UNITED STATES PATENT AND TRADEMARK OFFICE

APPLICATION NO.	FILING DATE	FIRST NAMED INVENTOR	ATTORNEY DOCKET NO.	CONFIRMATION NO.
10/709,534	05/12/2004	Bradley P. Jones	FIS920040035US1	3533
29371	7590	09/07/2005	EXAMINER	
CANTOR COLBURN LLP 55 GRIFFIN ROAD SOUTH BLOOMFIELD, CT 06002			COLEMAN, WILLIAM D	
			ART UNIT	PAPER NUMBER
			2823	
DATE MAILED: 09/07/2005

Office Action Summary	Application No. 10/709,534	Applicant(s) JONES ET AL. (P)	
	Examiner W. David Coleman	Art Unit 2823

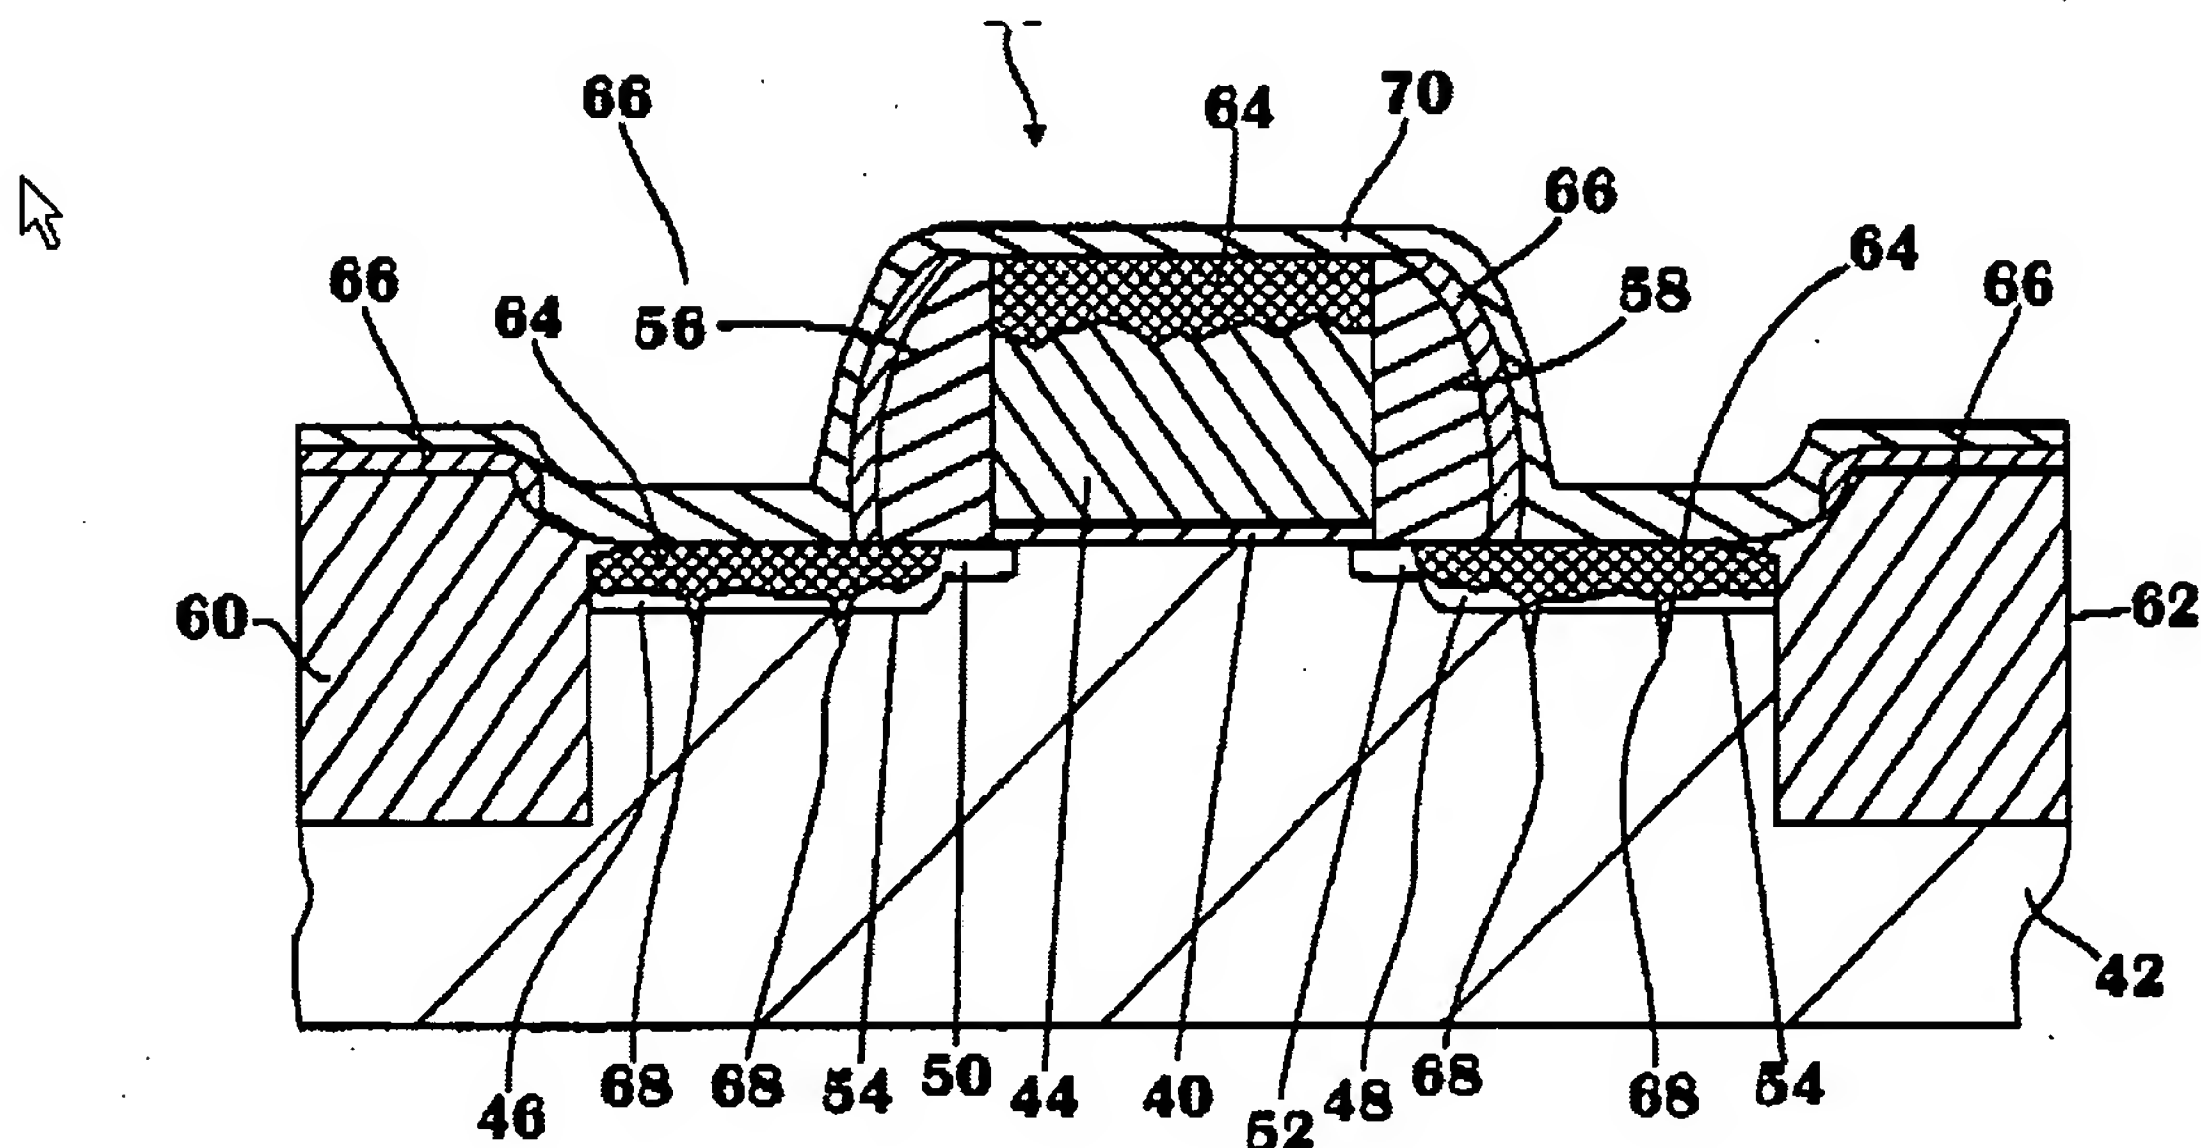
4. Claims 1-12 are rejected under 35 U.S.C. 102(b) as being anticipated by Wieczorek et al., U.S. Patent 6,207,563 B1.

Wieczorek discloses a semiconductor process as claimed. See FIGS. 1-7 and claims 1-39 where Wieczorek teaches the following limitations.

5. Pertaining to claim 1, Wieczorek teaches a method for reducing voiding between a first layer and a second layer formed over said first layer during a semiconductor annealing process, the method comprising:

forming a counter tensile layer over said second layer, wherein said counter tensile layer is selected from a material such that an opposing directional stress is created between said counter tensile layer and said second layer, with respect to a directional stress created between said first: layer and said second layer (see claims 21-39,)

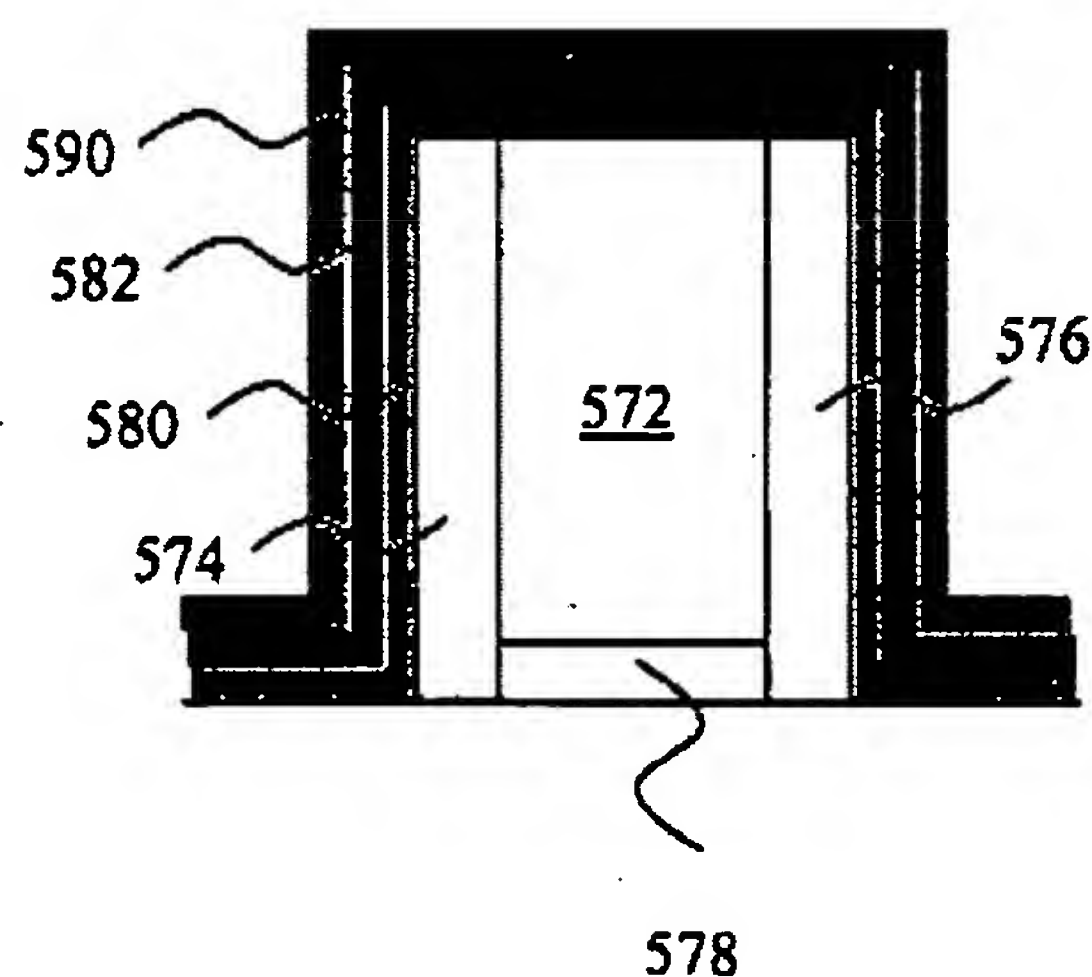
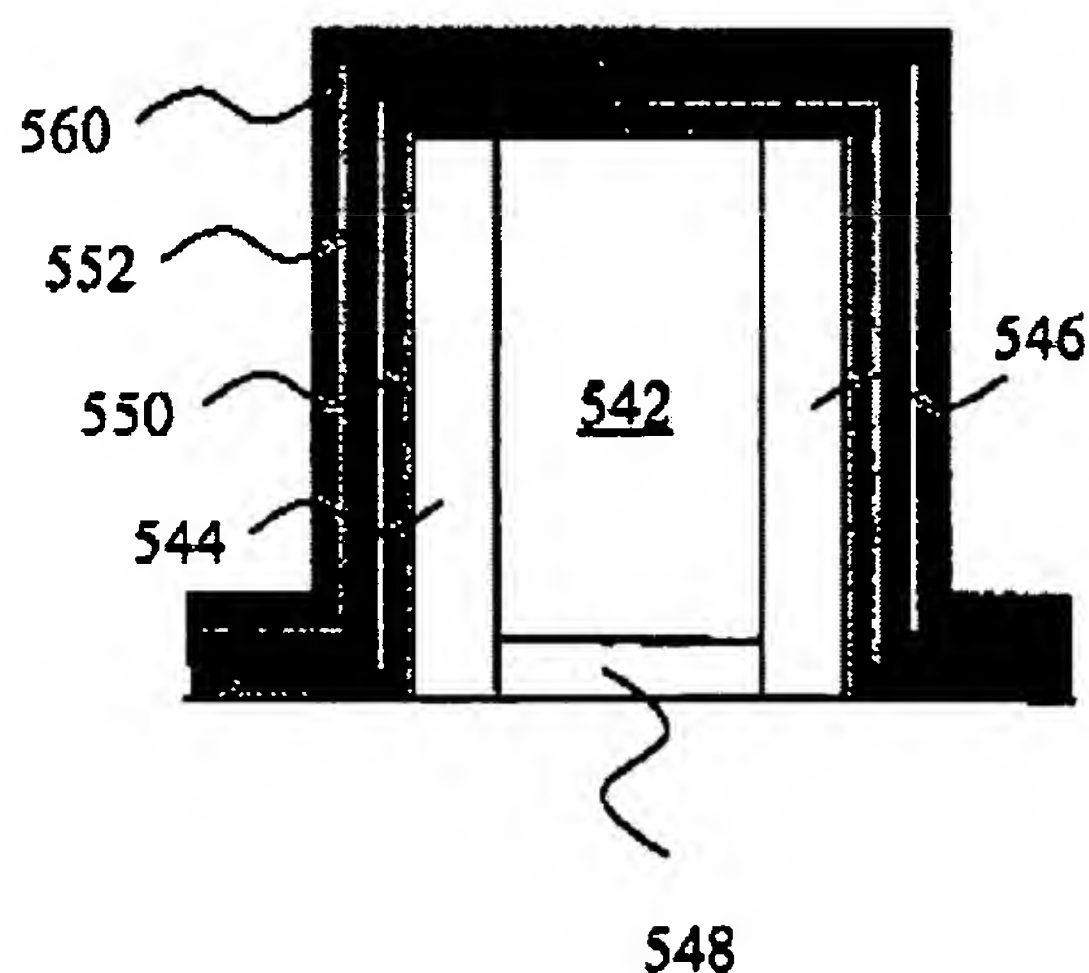
17. Claims 1, 2, 3, 4, 6, 7, 8 and 12 are rejected under 35 U.S.C. 102(e) as being anticipated by Lin et al., U.S. Patent Application Publication US 2005/0156208 A1.

Lin discloses a semiconductor process as claimed. See FIGS 1-8K and in particular FIGS. 5a-5i where Lin teaches the claimed limitations.

forming a counter tensile layer **560** over said second layer **552**, wherein said counter tensile layer is selected from a material such that an opposing directional stress is created between said counter tensile layer and said second layer, with respect to a directional stress created between said first layer **550** and said second layer (cobalt/titanium/cobalt, see [0078]).
